Mackenzie Valley Highway Environmental Assessment

Draft technical re-scoping session report

October 13, 2026

Figure 3: Map representing the four route options proposed by GNWT in the GSA

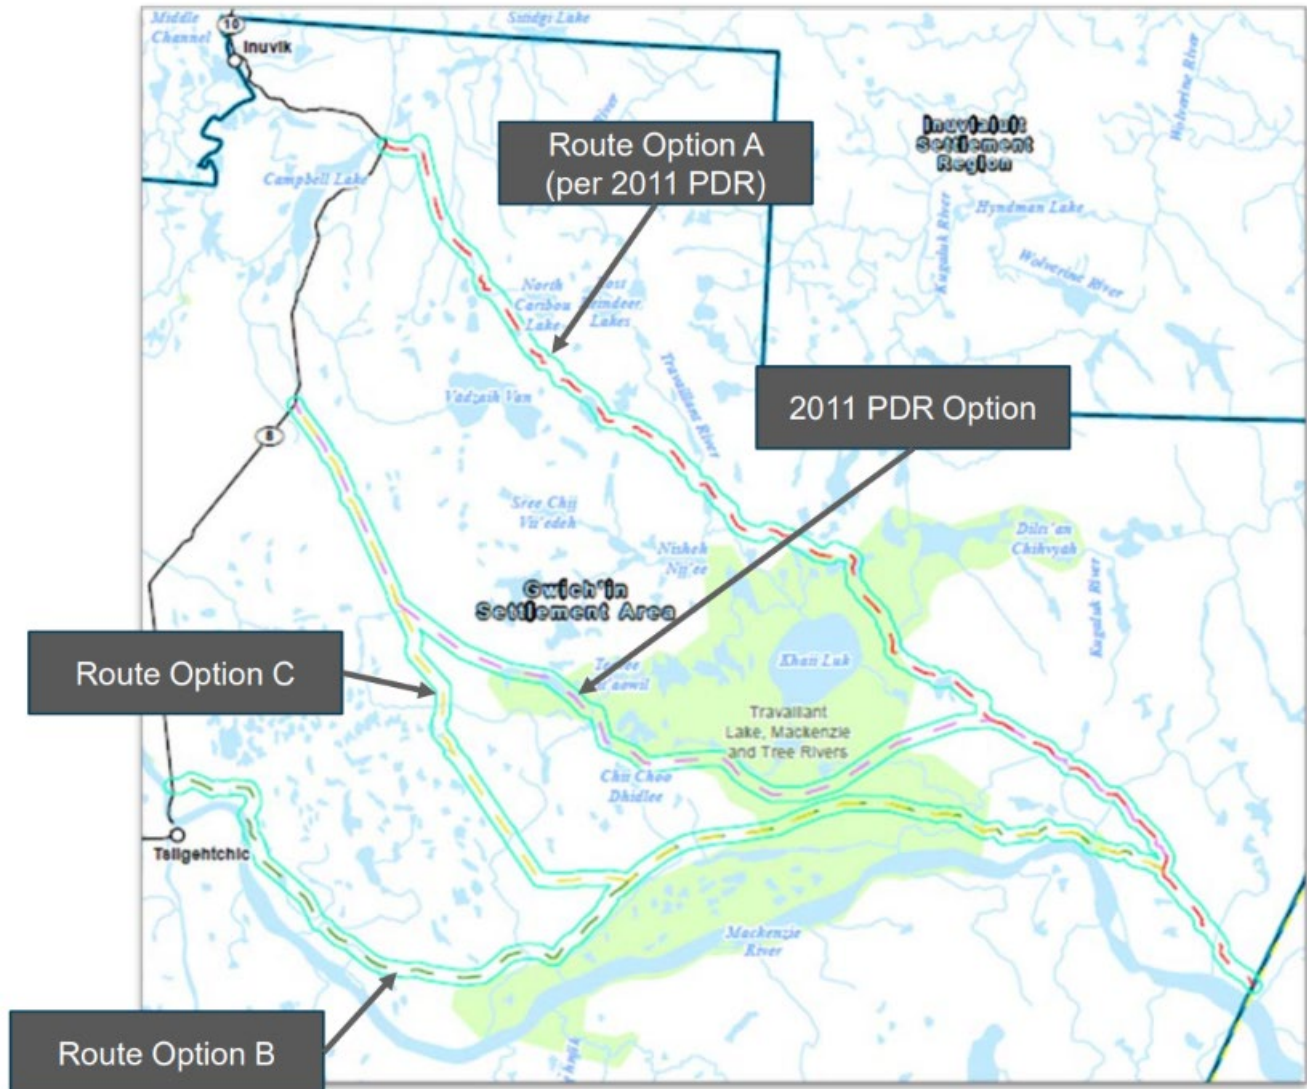
- Options vs. alternatives:** GNWT stated it will not propose a preferred route option in the DAR. GNWT will propose all four routes as options (see Fig. 3), rather than propose one preferred route and describe three other alternatives. The route choice is subject to future engagement in the northern part of the proposed project. There is no timeline yet for choosing a route. Parties said they would prefer a complete Revised DAR (with a preferred route) rather than a rushed one.

- **MVEIRB:** The EA would prefer to look at a preferred option; it would help parties focus their efforts on the intended route.
- **Gwich'in Land Use Plan:** Two of the proposed routes go through the Conservation area (see the [Gwich'in Land Use Plan](#)), which would require an amendment to the Gwich'in Land Use Plan. GNWT will consult with the Gwich'in Land Use Planning Board for routing and mitigation. It will also consider the Gwich'in Land Use Plan's conditions and recommended actions in the route design. GNWT does not yet know how much of the proposed route corridor and travel lanes will pass through historic or protected areas. The TOR could request this information.

- **Fibre line:** GNWT has not yet confirmed whether it would relocate the fibre line if it does not select option A (see Figure 3) as the preferred route.
- **Quarries:** GNWT does not yet have information on the number and location of quarries, but it will include it in the Revised DAR.
- **Déline turnoff:** GNWT is considering having a laydown staging area at the turnoff before the winter road to Déline; MVH would extend the winter road season for Déline.
- **Barge landings:** Barging is currently restricted because of low water levels. Should there be plans to increase barge landings for the highway to be built? What is the timeline to obtain more information on the suitability of barging conditions and plans in place to develop these landings?
 - **GNWT:** The unreliability of barging is one reason for this project. GNWT can provide more information on landings later.
